6. Heritage Alteration Permit Application No. 00195 for 1070 Joan Crescent

Subject: Heritage Alteration Permit Application No. 00195 for 1070 Joan Crescent

Craigdarroch Castle
Proposed Visitor Centre

RE: 1070 Joan Crescent revised proposal for Rezoning and Heritage Alteration Application.

Site Context Plans

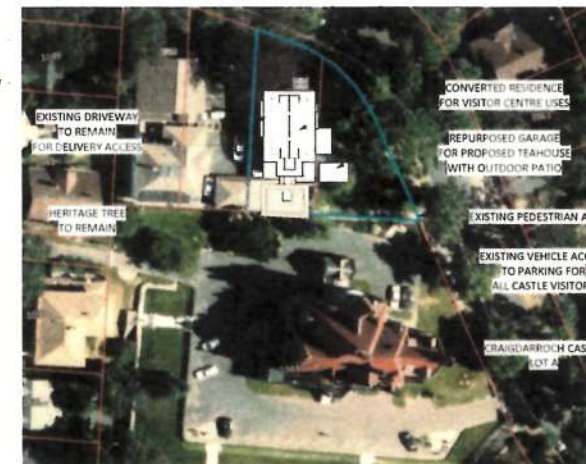
Vehicle calculations have been revised on A1.01, per Schedule C and in conjunction with comments from staff review on the Zoning Plan Check sheet.

Lot Width & Setback
Clarifications

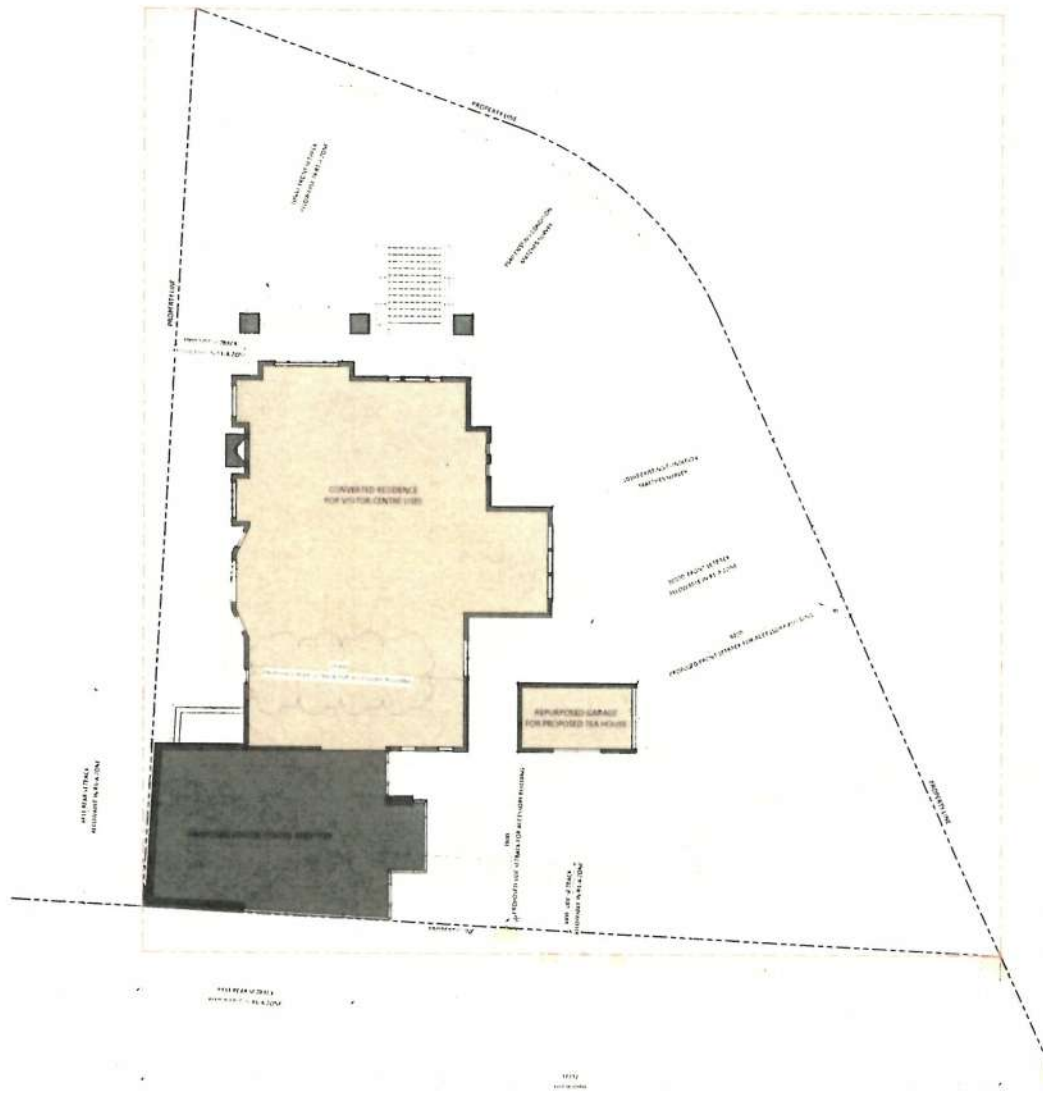
- a) Lot Width & Setbacks: New sheet A1.05 provided and setbacks revised in the Project Information Table on A0.00.
- b) Vehicle & Bicycle Parking: Revised and clarified in item 2 listed above.
- c) Garage Detail: New sheet A3.10 & A3.11 provided.
